ADDENDUM NO. 2
POTTAWATTAMIE COUNTY, IOWA
COURTHOUSE – Chiller Improvements
Council Bluffs, Iowa

HGM PROJECT # 107419D

DATE OF ISSUE: October 29, 2019

M1

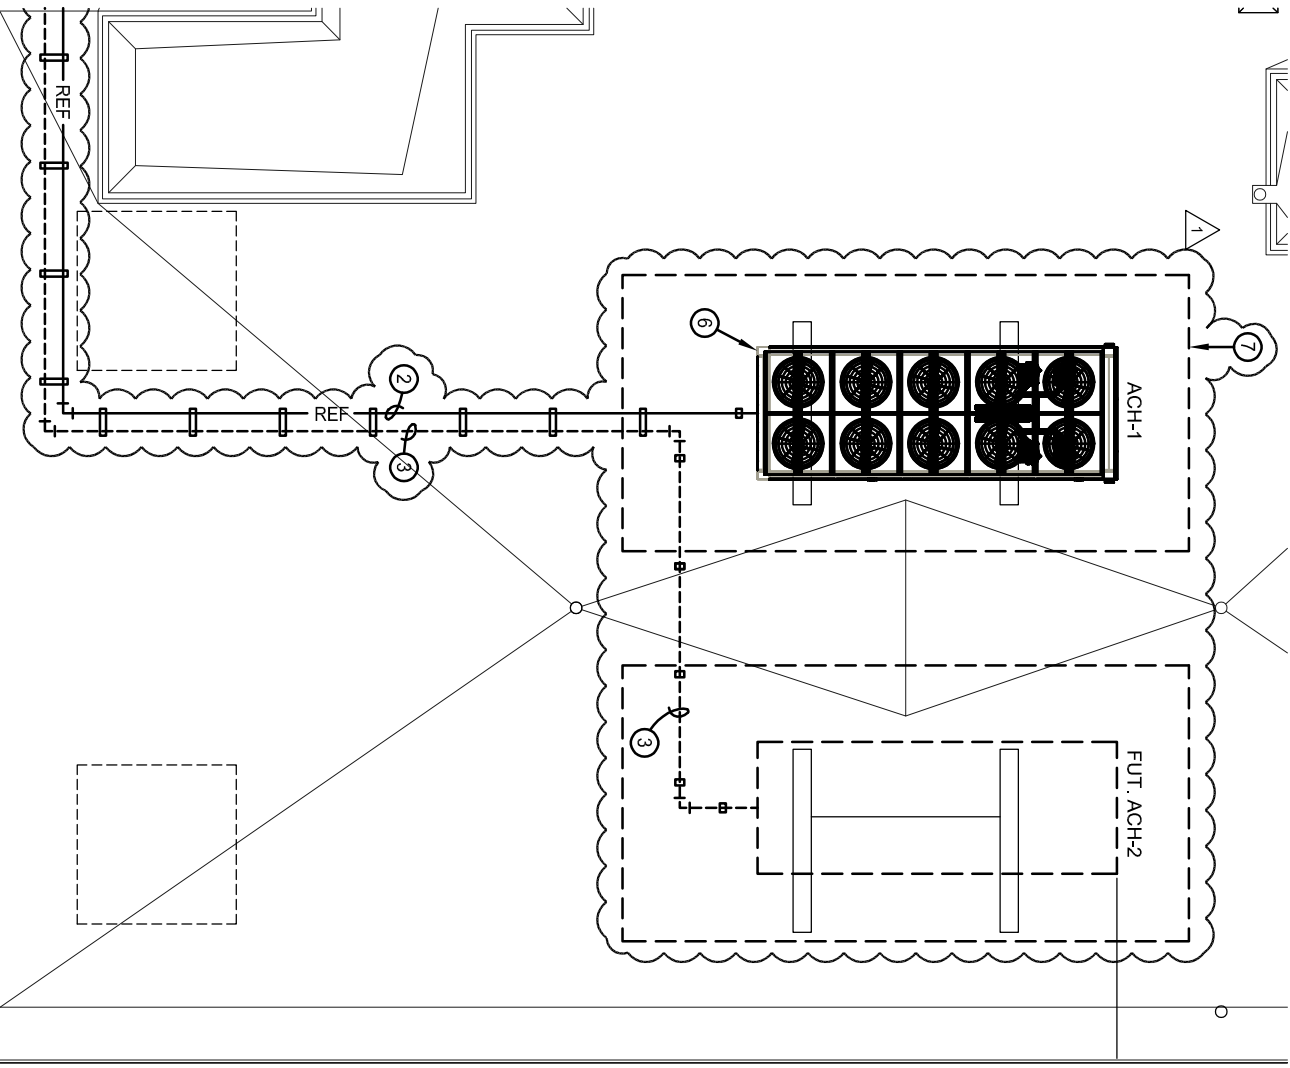
SHEET M1.6 – ROOF MECHANICAL PLAN

Revised chiller locations and pipe routing. Refer to sketches M1 & M2.
